**ARCHIVE 1
ED-01/84 to ED-129/97**

**Director's Rulings
Issued Prior to May 5, 1997
under MCCR**

**Elevating and Amusement Devices Safety Program
Technical Standards and Safety Authority**

FIGURE 1 - ROLL (SPRING) PIN

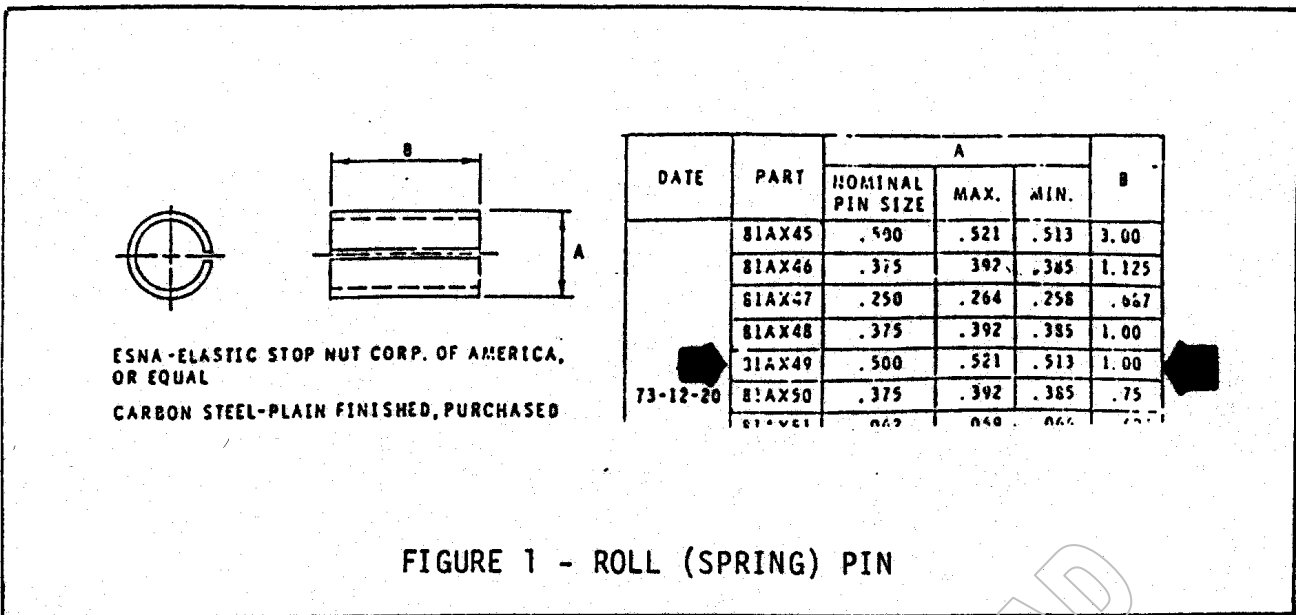
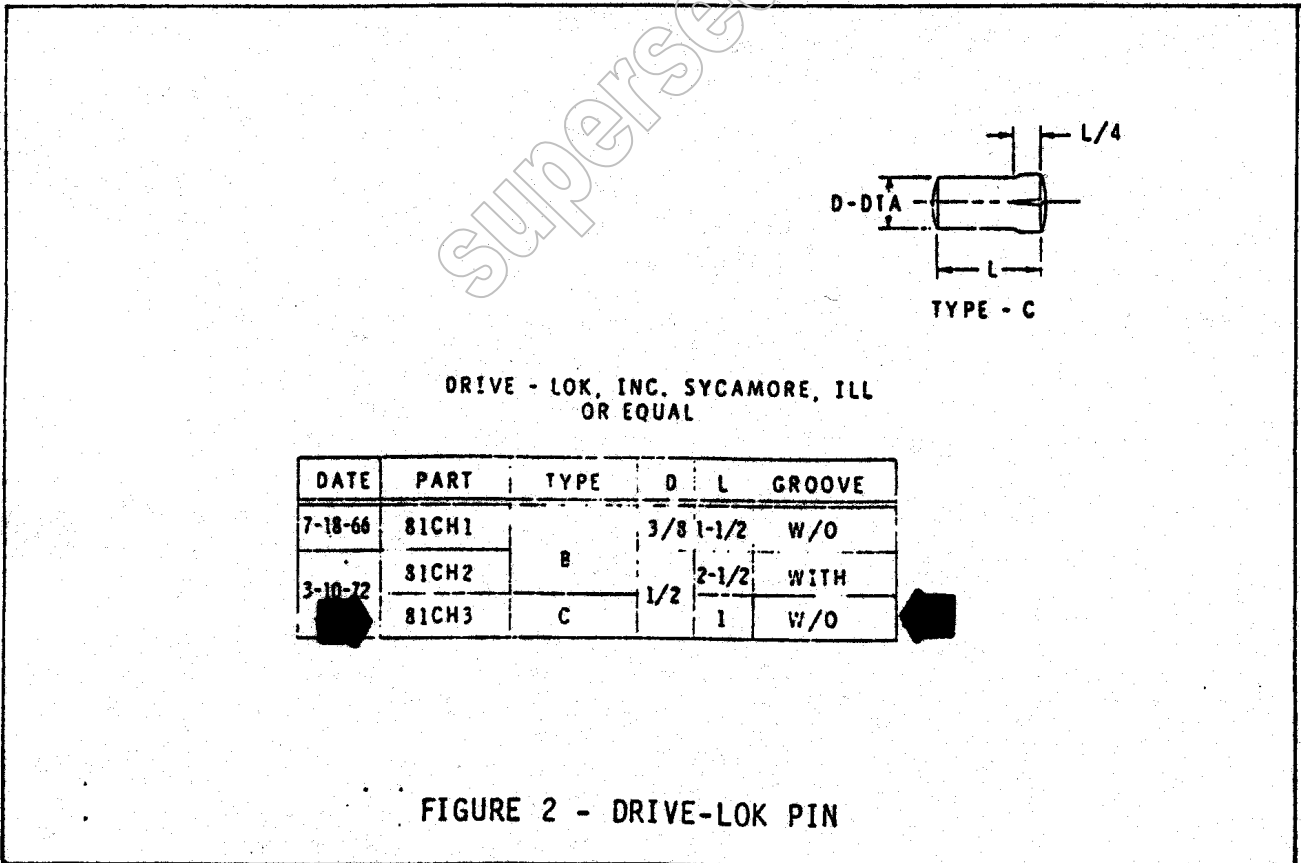
A majority of Otis "R" type governors manufactured between 1966 and 1980 were equipped with ROLL (SPRING) PINS, part #31AX49 (as shown in figure 1**). It has been found that in time such pins may lose their original strength or for other reasons may cease to perform the intended function.

Since the end of 1980, Otis has been using Drive-Lok pins, as shown in figure 2**.

Roll (spring) pins (figure 1**), if used to secure the bale arm of an "R" governor, must be replaced with Drive-Lok pins or equivalent securing means.

Figure FCR
Symbol for Fire Code Retrofit Elevator

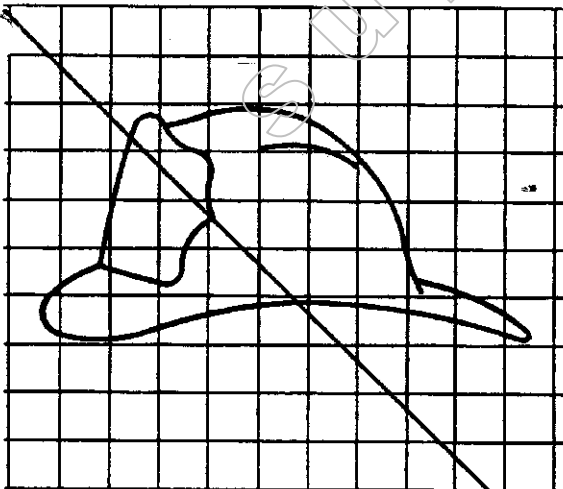
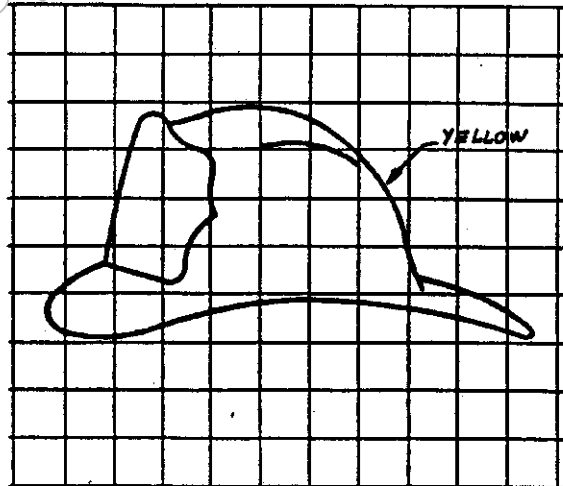
~~A symbol showing a red firefighter's hat on a contrasting background, as shown in Figure 8, shall be used exclusively to identify elevators that comply with Clause 3.12.15. This identification shall be located on the elevator entrance frame or adjacent to it, at the emergency recall level and also in the car adjacent to the in-car emergency switch. The identification on the entrance frame, or adjacent to it, shall be a minimum of 50 mm in height, and the identification in the car shall be a minimum of 10 mm in height.~~

The keys used for the emergency recall switch (see rule FCR.2) and in-car emergency service switch (see rule FCR.8) shall be identical and shall be used exclusively for either these switches or for corresponding switches required in accordance with clauses 3.12.15.2 and 3.12.15.8 of CAN-B44. They shall be accessible to authorized persons only and shall be placed in a box conspicuously located and identified near the elevator hoistway.

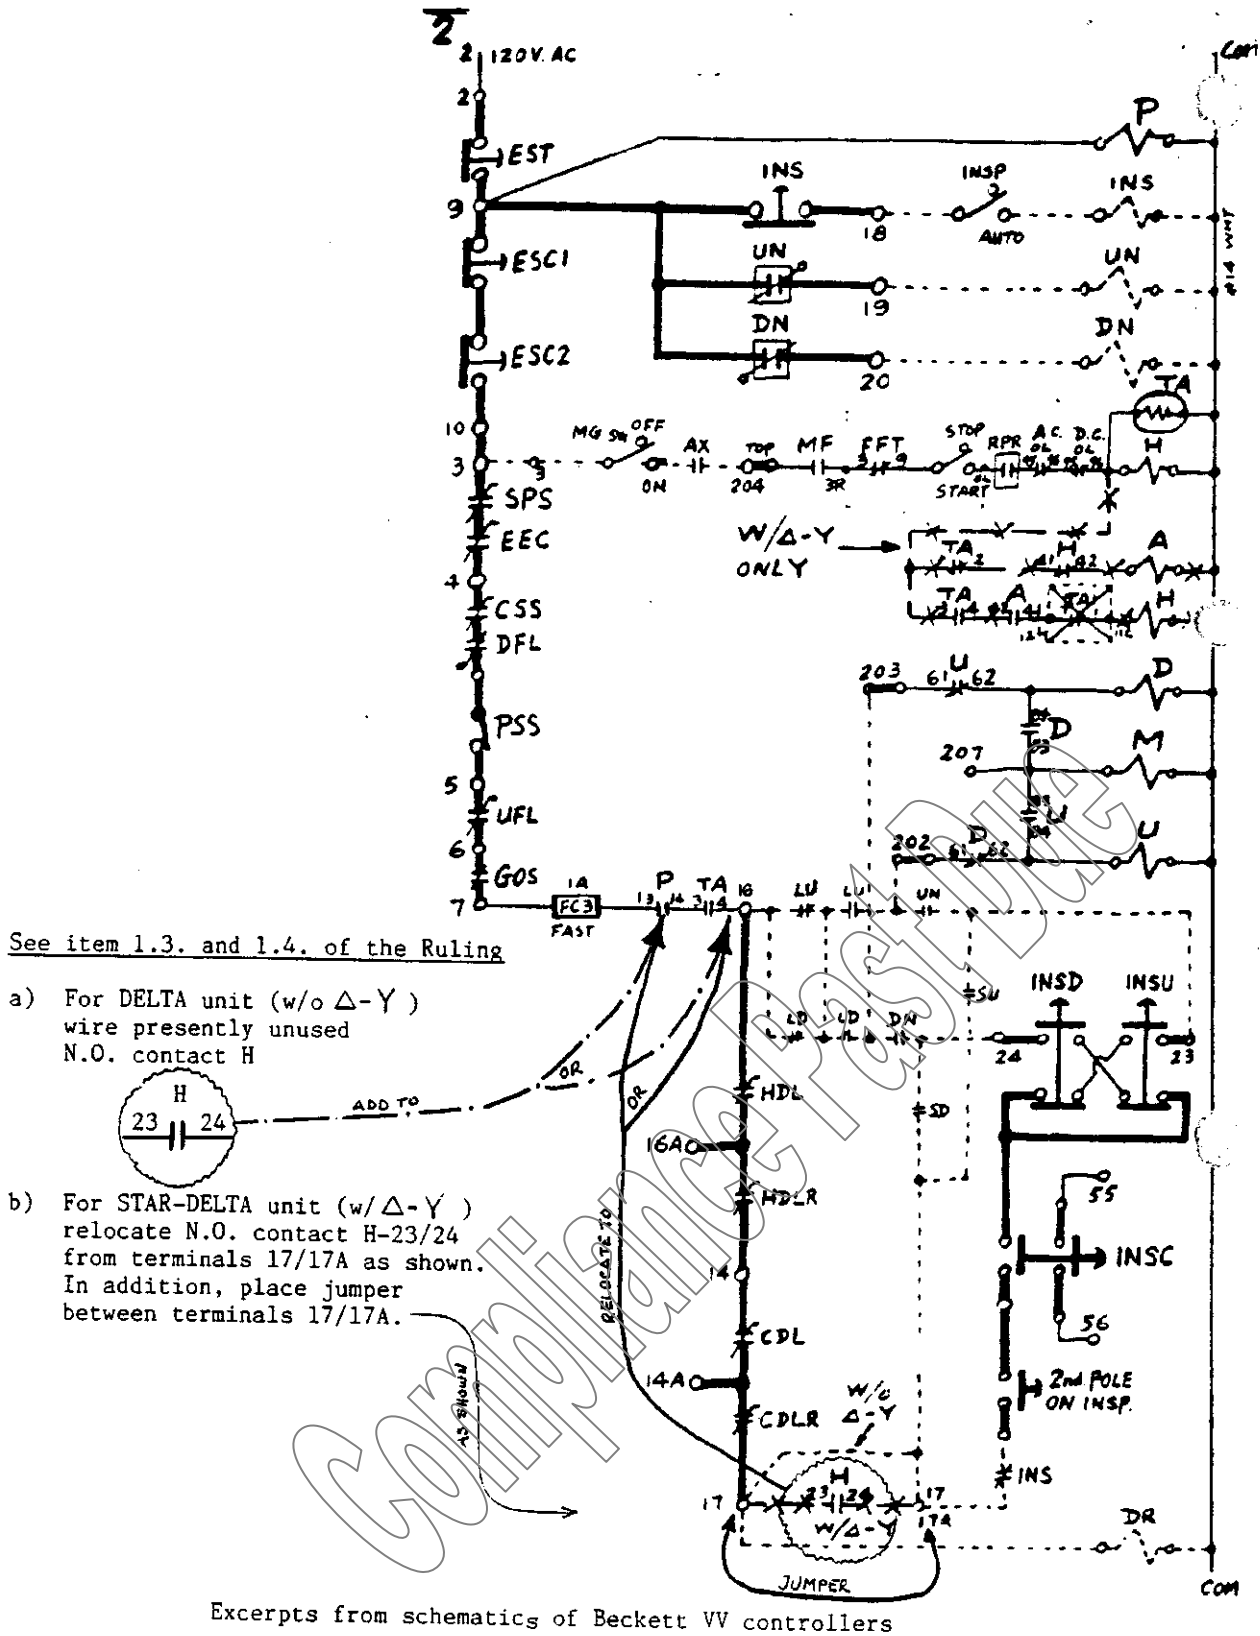
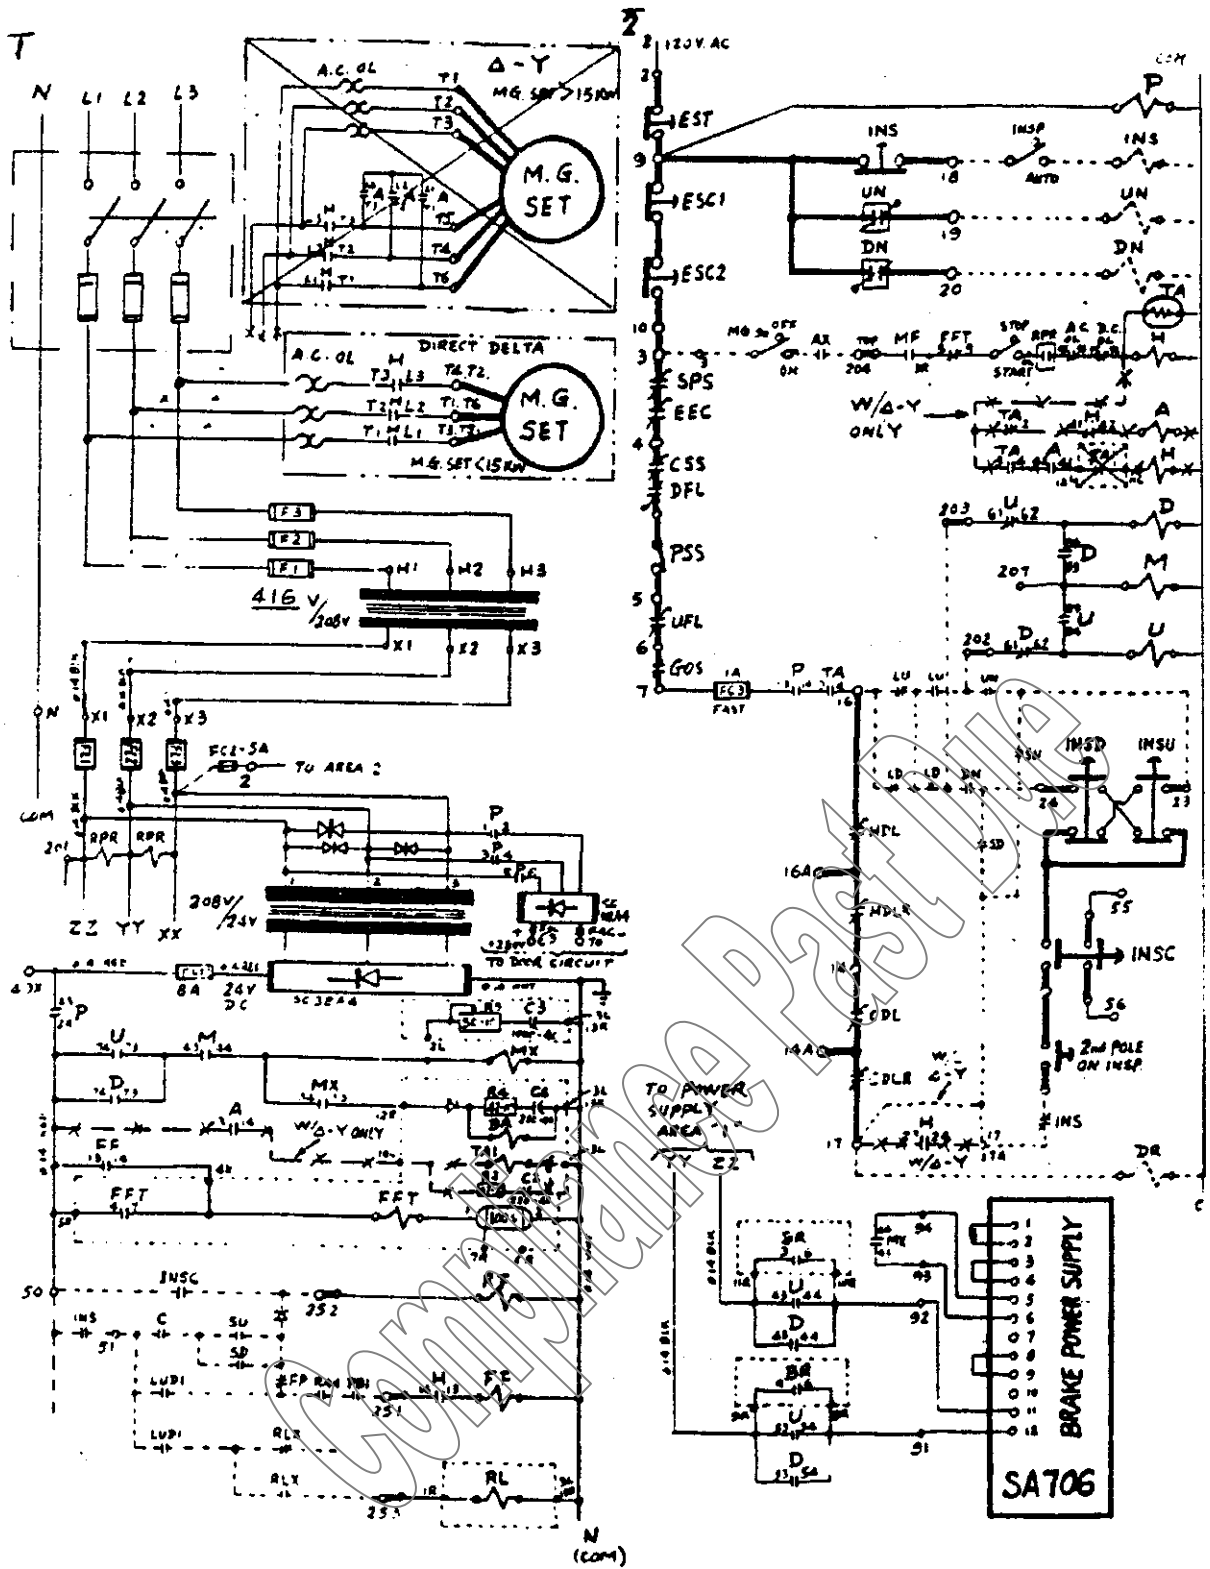
It is possible that contactor H fails to pick up, thus not energizing the generator, while simultaneously relay TS picks up giving signal to contactors D, U, M for "running conditions" and allowing the brake to be opened. Since the generator and drive motor are without power, the car will drift at uncontrolled speed up or down depending on the load in the car, creating unsafe conditions, (See excerpts from Beckett schematics on page 3 of this Ruling).

- 1.3 In order to prevent the possibility of the car having uncontrolled motion, the contractor proposed the following changes to the wiring of Beckett VV controllers (see schematics on page 2 of this Ruling).
- For units with direct DELTA start (marked w/o Δ -Y in the schematics), use the existing N.O. auxiliary contact 23/24 on contactor H, which is presently unused or install a new contact if necessary and wire it between terminals TA/4 and 16 (see also 1.4. below).
 - For units with STAR-DELTA start (marked w/ Δ -Y in the schematics) relocate the existing N.O. auxiliary contact 23/24 from terminals 17/17A to between TA/4 and terminal 16. (see also 1.4. below). Install jumper between terminals 17 and 17A.

- 1.4 Beckett Elevator Ltd. agreed with the proposed changes but suggested that the H auxiliary contact 23/24 could be wired in the present location of the P (N.O.) contact 13/14, leaving this P contact obsolete.

Figure 1 - Type M0, old model - Interlock contacts in jammed position

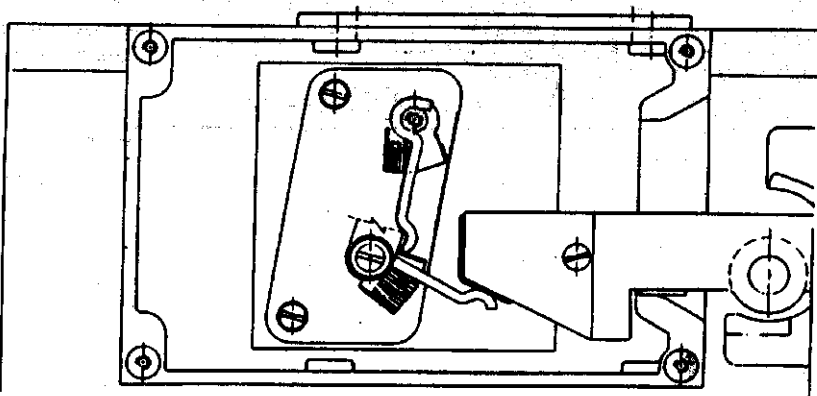
If the GAL interlock contact is jammed as shown on figure 1, the elevator may operate with an open hoistway door creating a serious safety hazard.

- 2.1 Contact assembly replacement kits are available from GAL:
 - a) For type MO - replacement kit INT-1-15R or L
 - b) For type MOCP - replacement kit INT-2-15R or L
- 2.2 The kits include the contact assembly (where a "boss" is added to its base as shown in figure 4) as well as the contact bar keeper, to be simultaneously replaced on the interlock beak.

Figure 4 - Type M0, new model - New contact assembly with "boss" added.

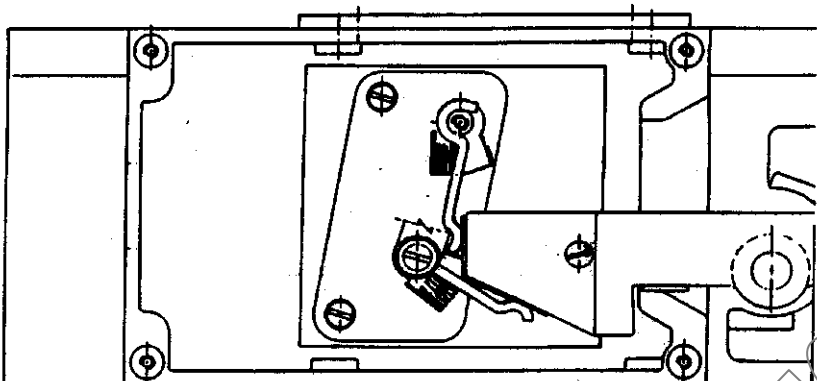
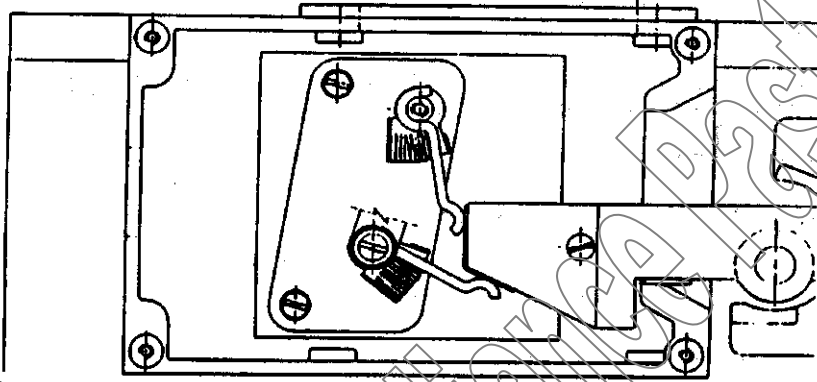
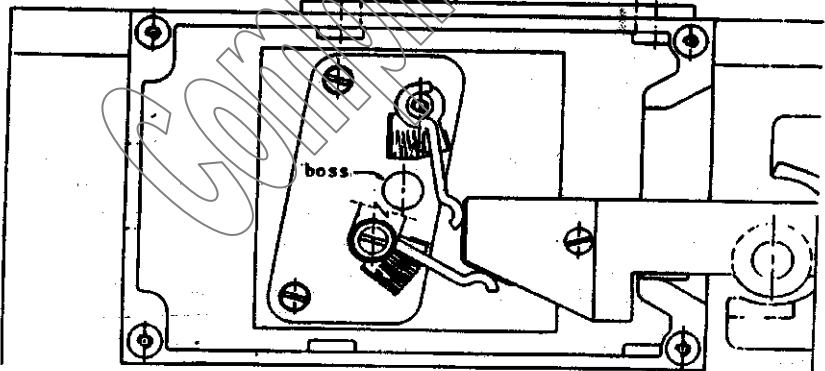
Although the "jamming" is not possible if the position of the contact and the interlock beak is correctly adjusted (as shown in figure 3), we have been informed that GAL redesigned the subject interlock assemblies several years ago, by adding a "boss" in the contact base (as shown in figure 4) to eliminate "jamming" even in the case of any misadjustment.

EXHIBIT 1
LOCATION OF PINS - GENERAL VIEW FROM HOISTWAY SIDE
AND DETAIL OF EXISTING PIN

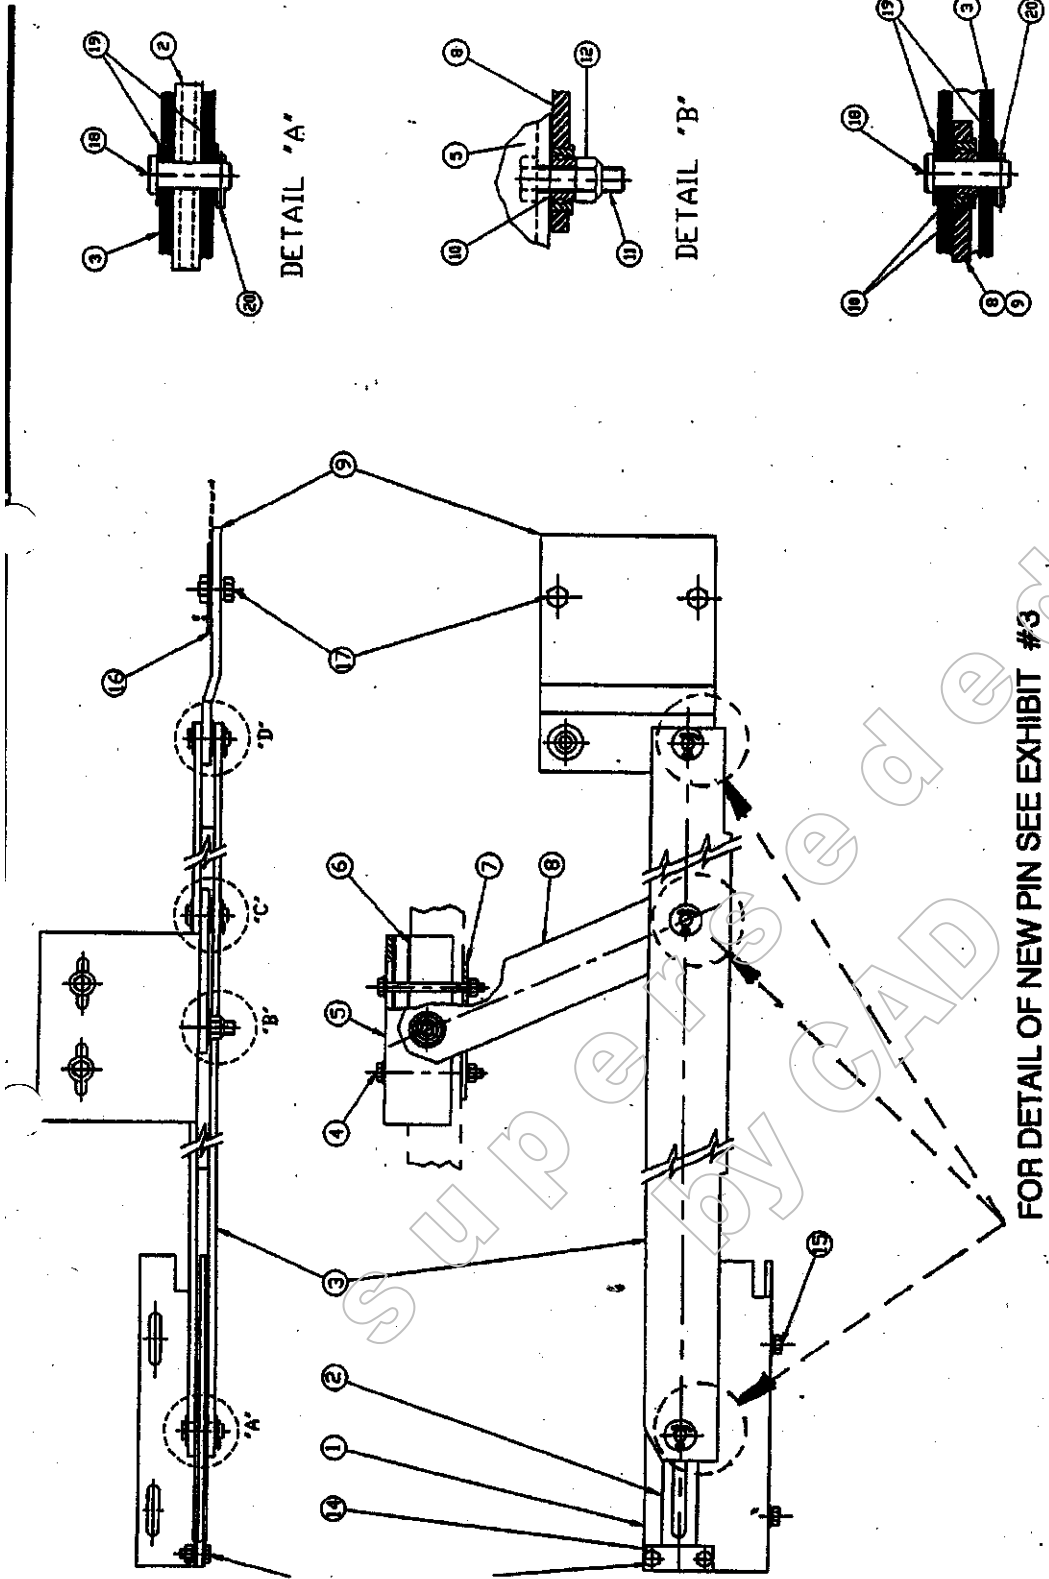
DETAIL OF EXISTING PIN
(FOR DETAIL OF NEW PIN SEE EXHIBIT #3)

REPLACE EXISTING PINS
INSTRUCTIONS ON EXHIBIT #2 & 3
